C. W. La Monte Company Inc.

March 16, 2022

SUBJECT: RESPONSE TO CYCLE ISSUE COMMENTS-LDR GEOLOGY
Phnx/Chan + Chung Residence
4004 Arroyo Sorrento Rd.
San Diego, CA 92107
Assessor's Parcel Number 307-060-43-00
City of San Diego Project No. 0698398

**SITE GEOLOGIC MAP 1
FIGURE NO. 2A**

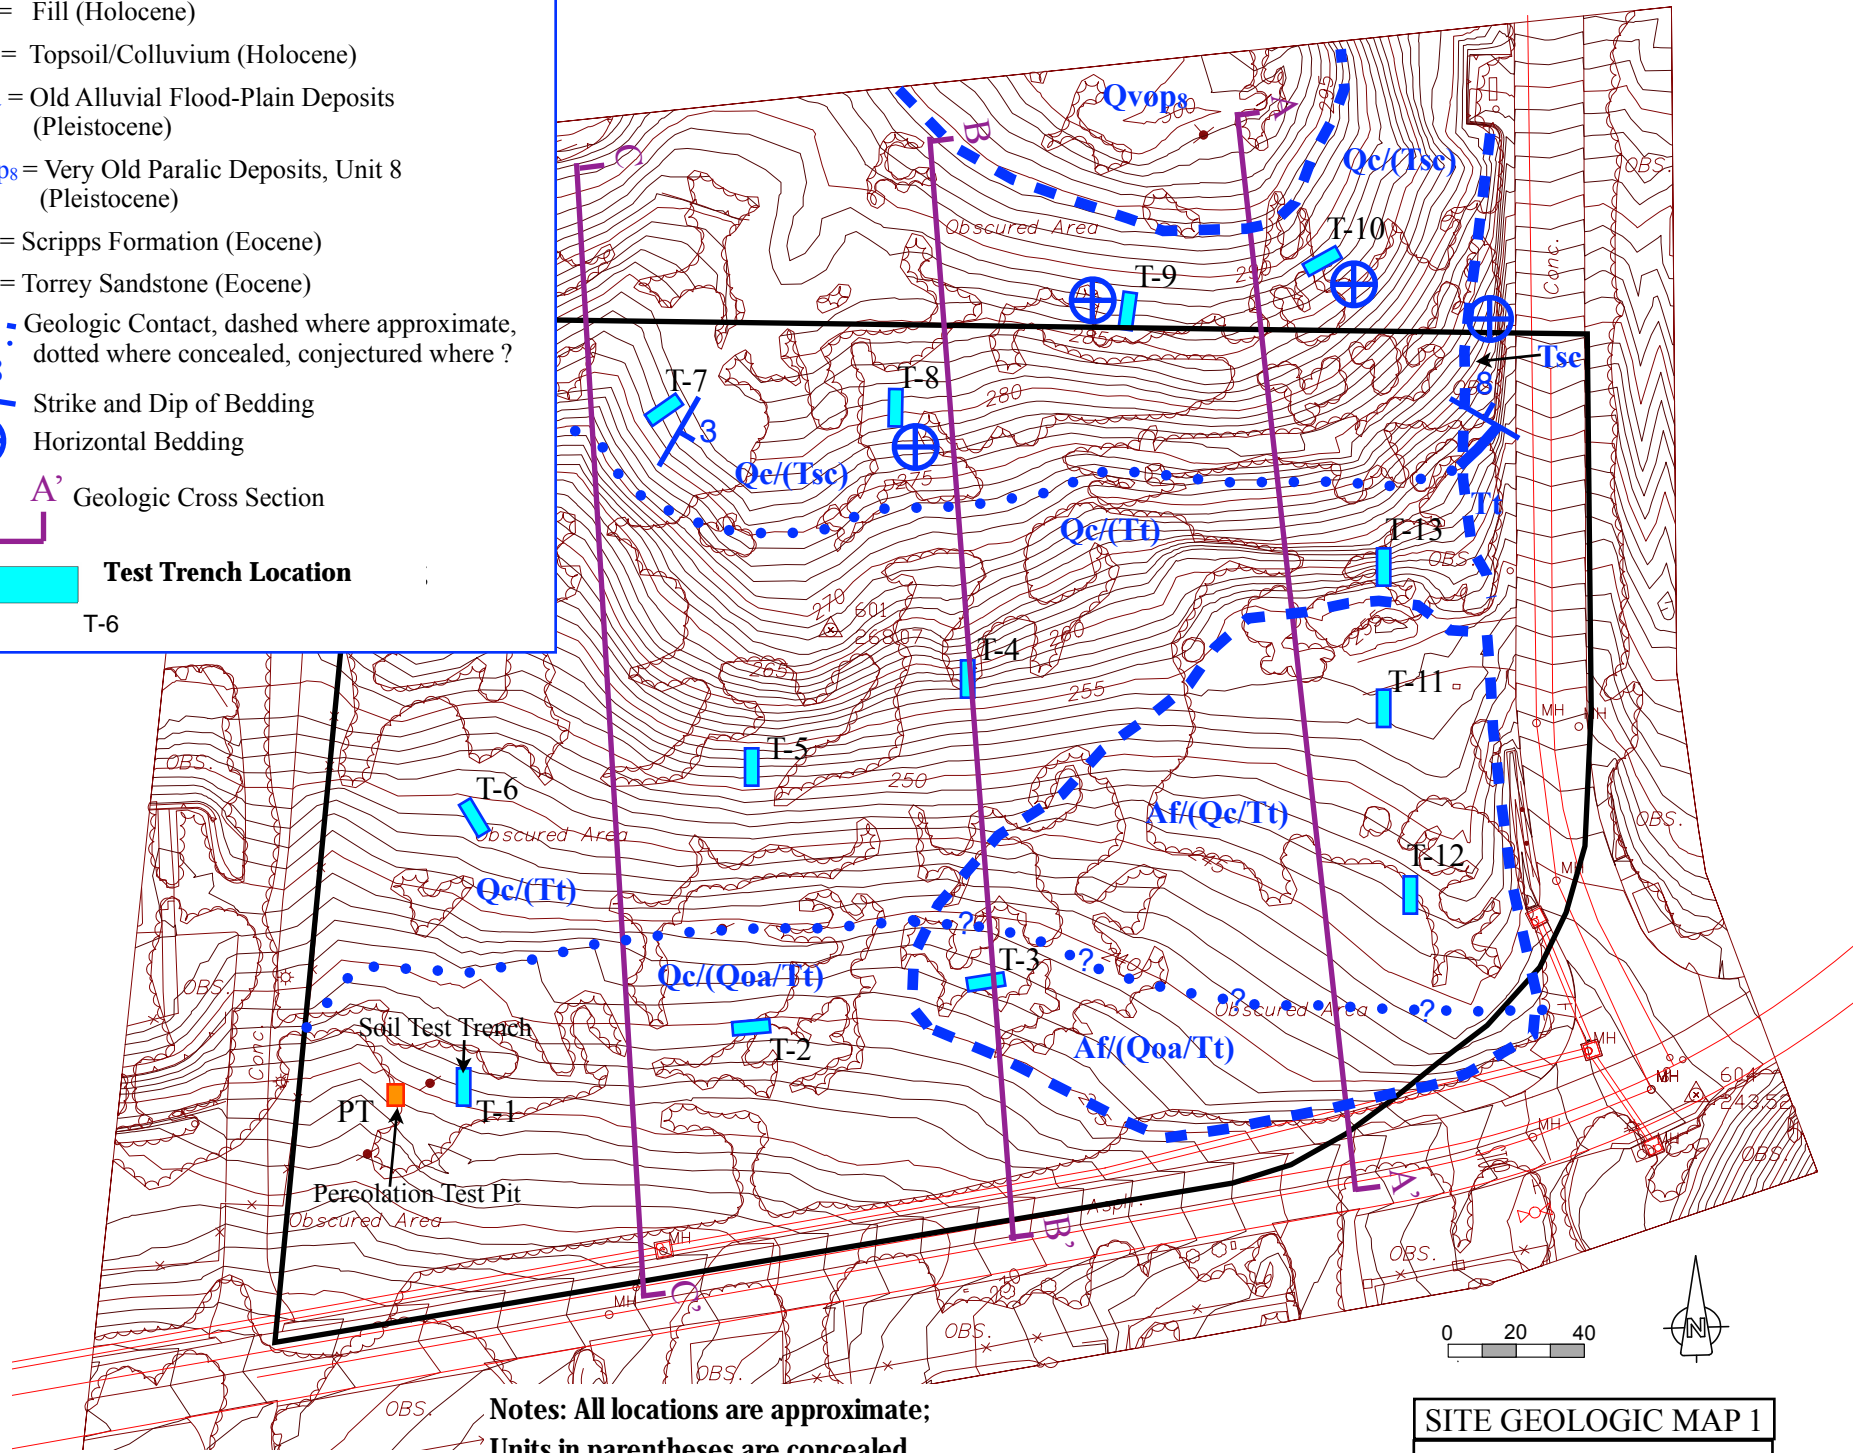
4. *The proposed development appears to have changed since the referenced report was prepared. Provide an updated Site Geologic Map, Figure No. 2B that shows the current proposed construction.*

The Site Geologic Map, Figure 2B, has been updated using the current grading plan as a base map and is attached to this report. Also for easier reference, a copy of the original geologic map (Figure 2A) is attached, which uses the existing topography as a base map. Additionally, the geologic cross sections from the 2017 report have been

**FIGURE NO. 2B
(Updated 3-16-22)**

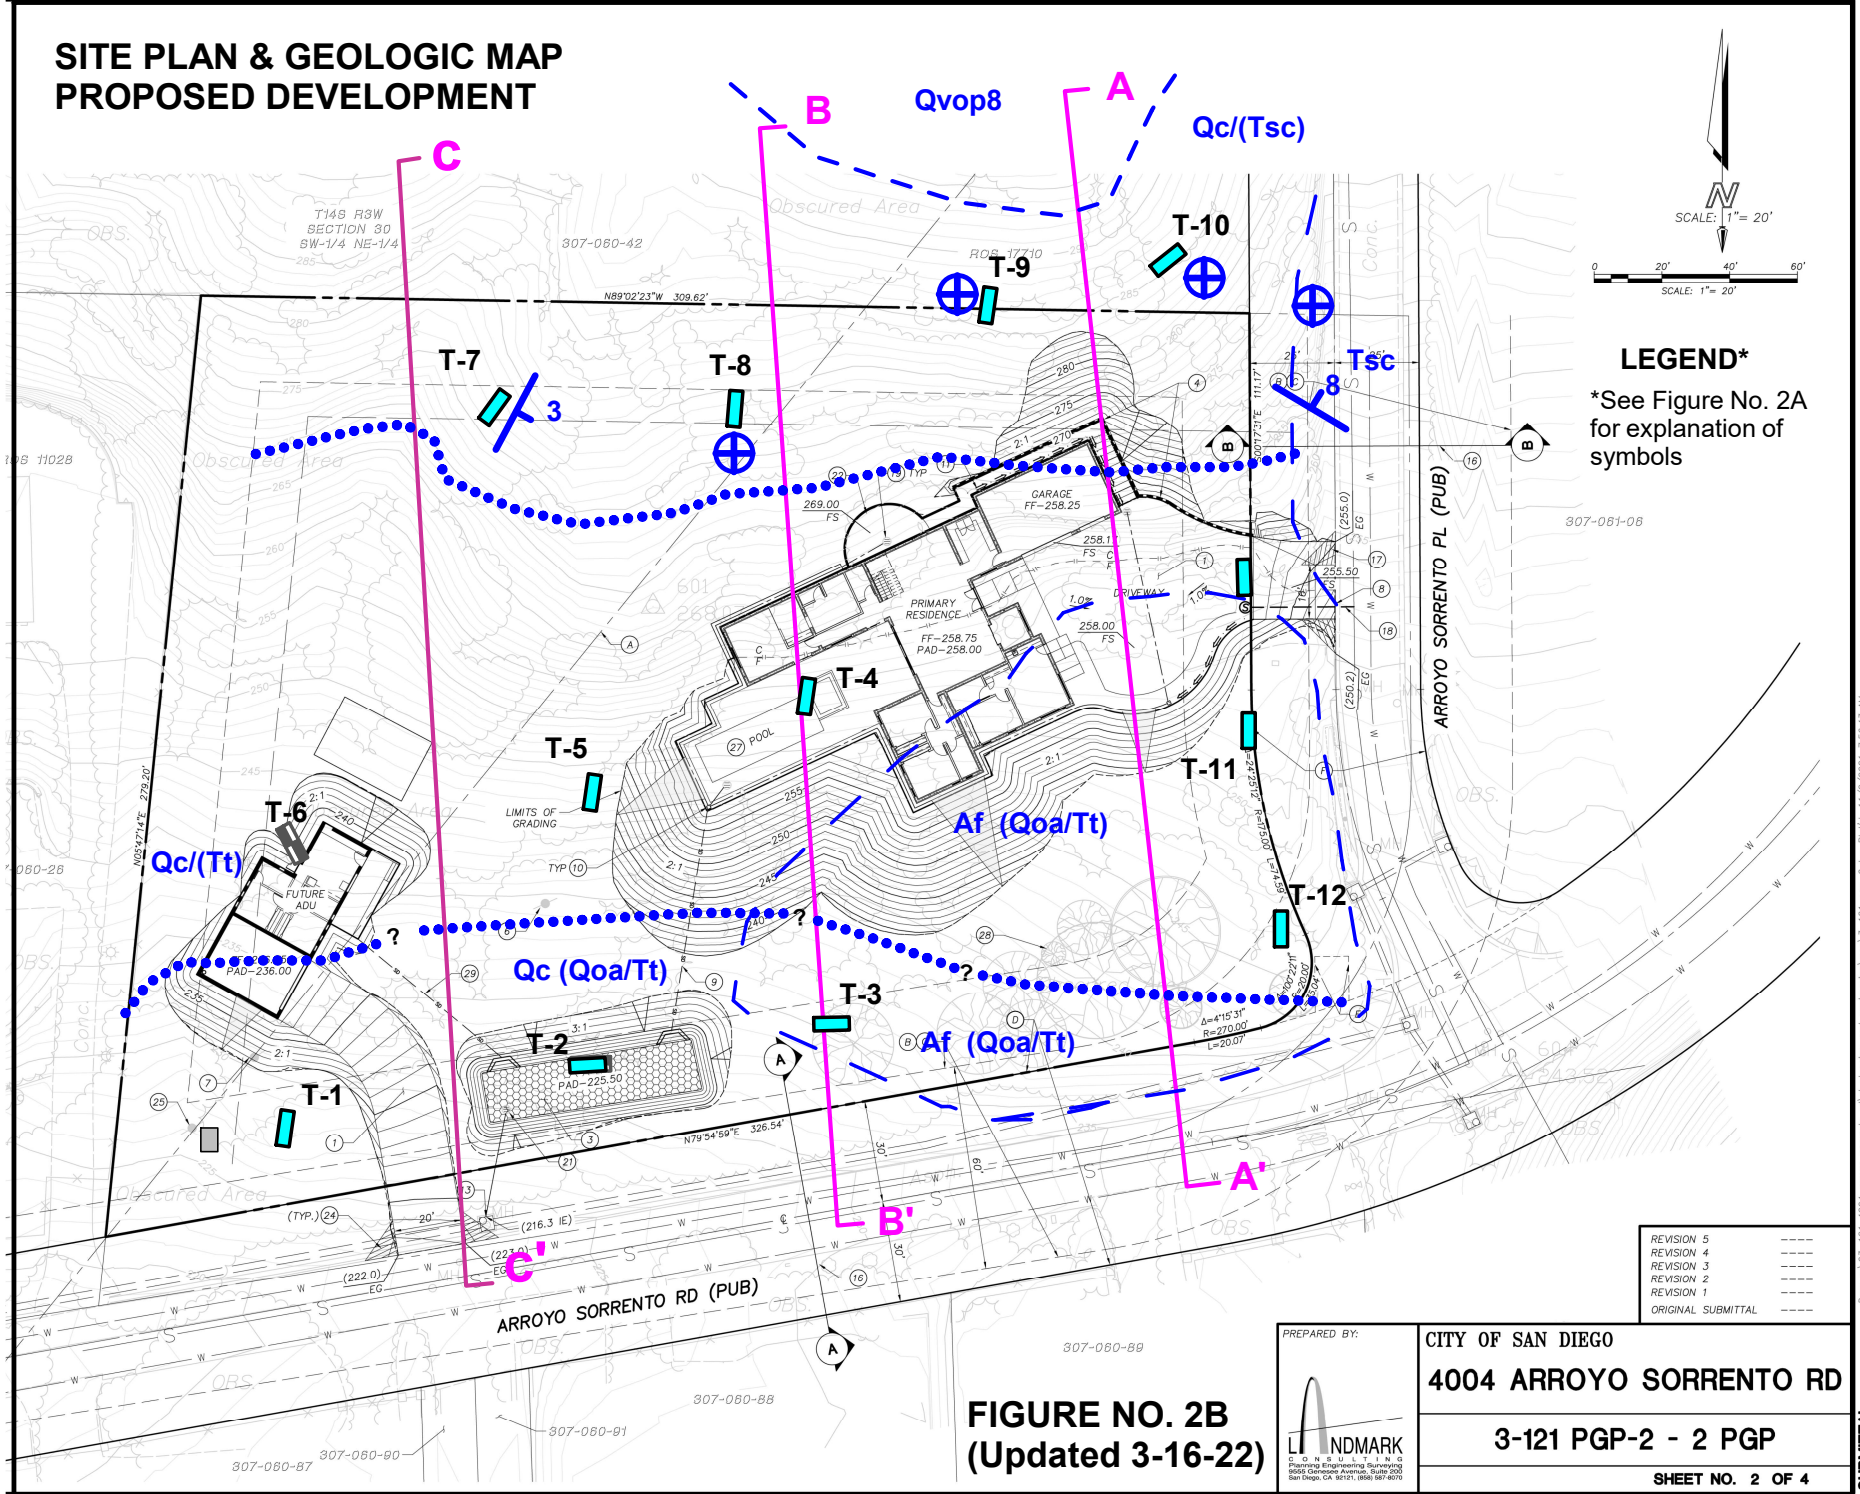
5. *Circumscribe the limits of anticipated remedial grading on the geologic/geotechnical map to delineate the proposed footprint of the project.*

As described previously, the current grading plan was used as a base map for the updated geotechnical map. The grading plan clearly indicates the area of the project that will be subject to grading. Grading will be limited to constructing the building pads, as indicated on the plan; the site will otherwise not be disturbed.
